Design Review Committee Meeting

700 Doug Davis Drive
Hapeville, GA 30354

September 15, 2021 6:00 PM

4.I. 482 Walnut Street Porch Remodel

01 FRONT ELEVATION
SCALE: 1/4" = 1'-0"

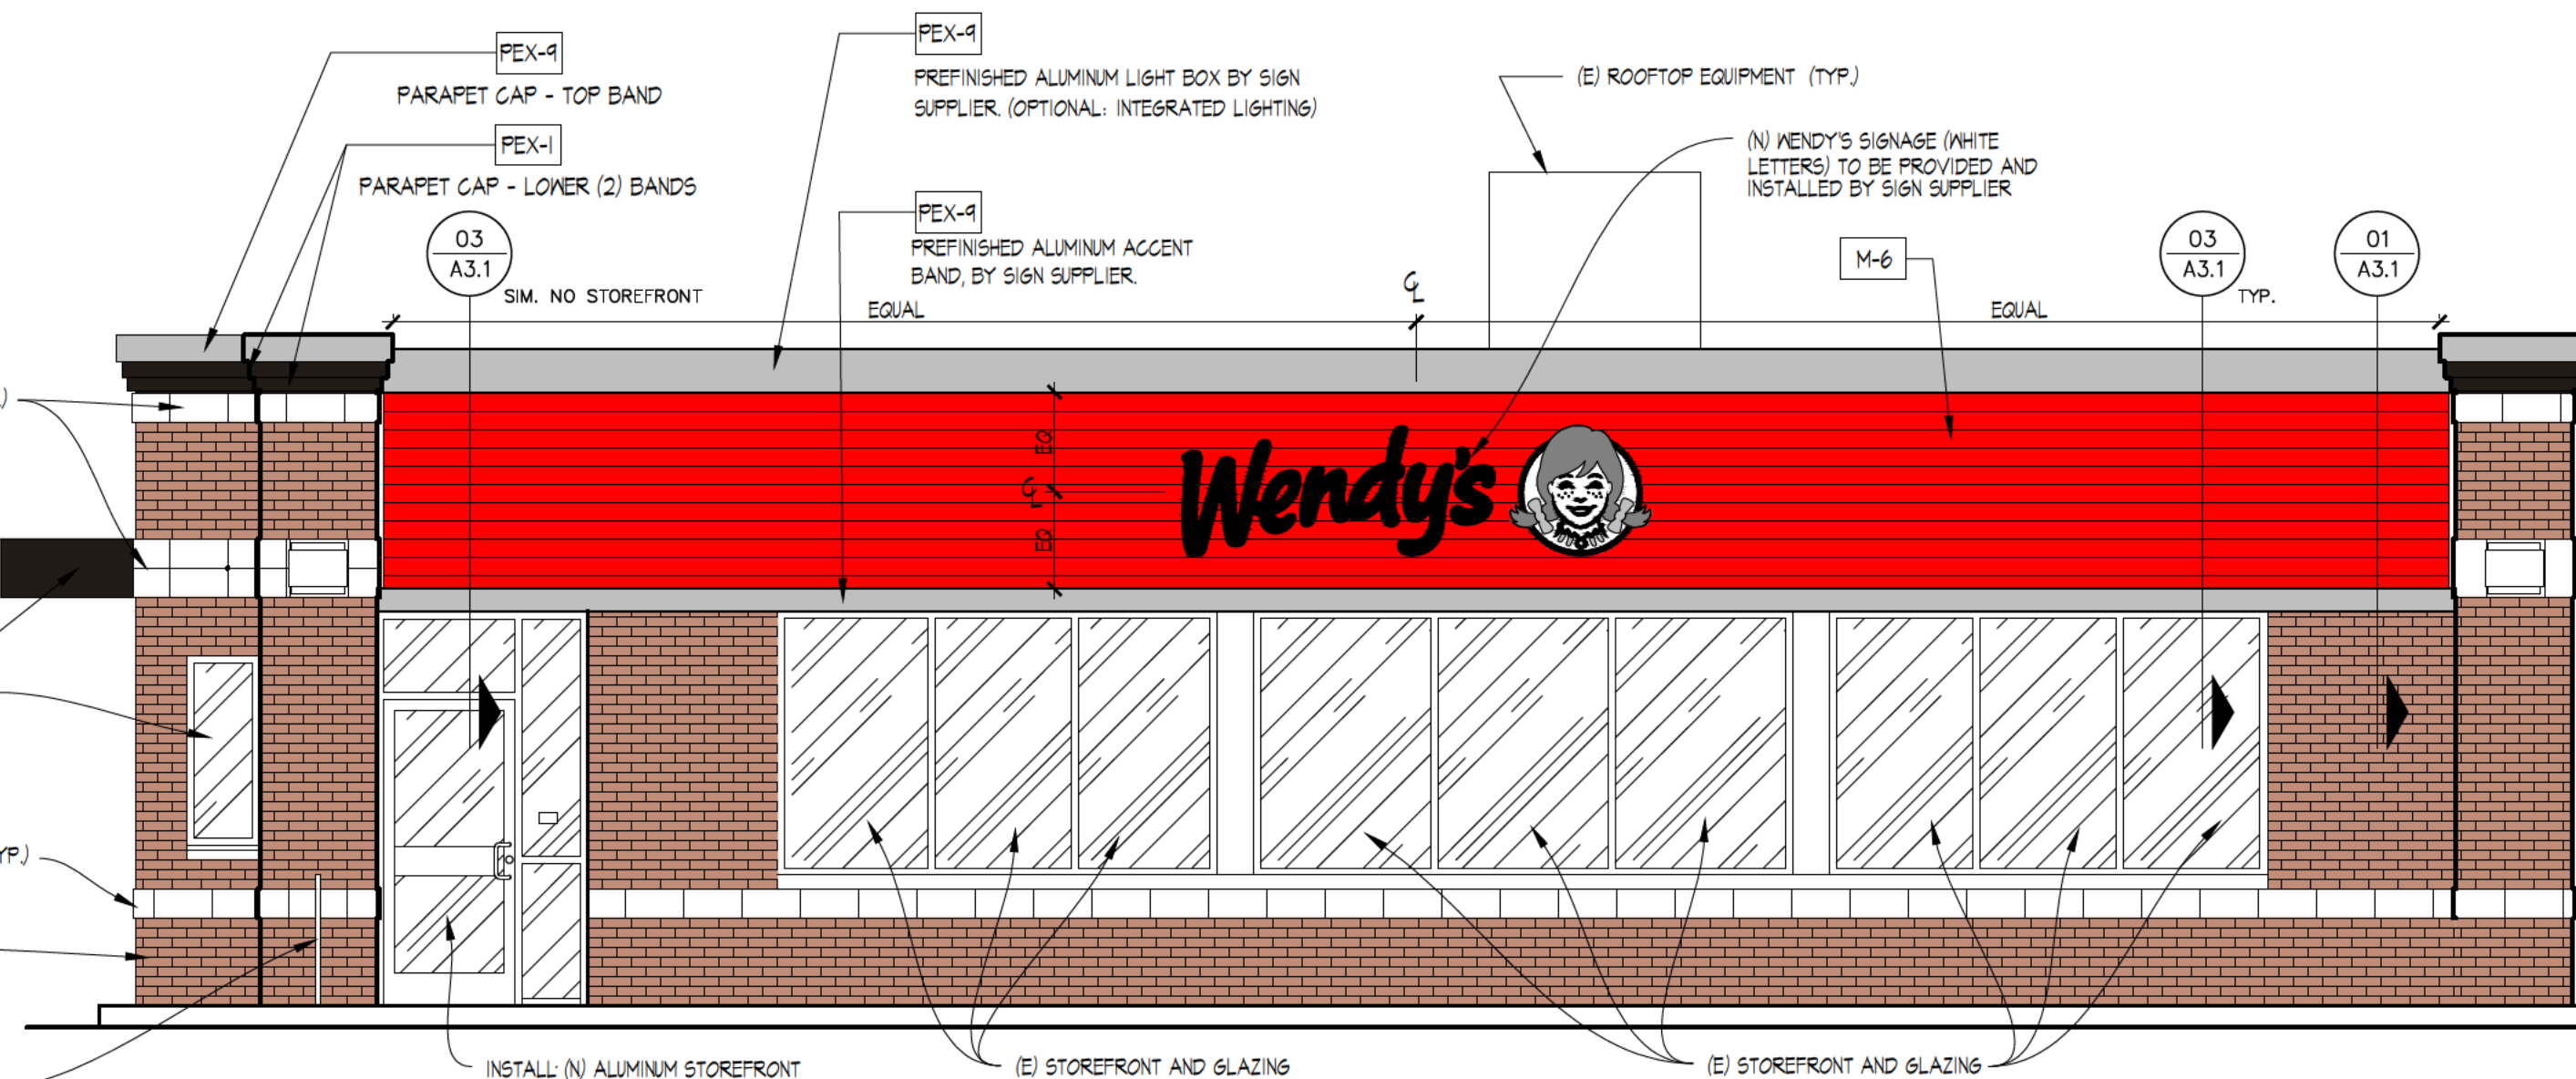
***Applicant should provide canopy information. Design Exception recommended for drive through canopy material and dimensions.
All signs require sign permit.***
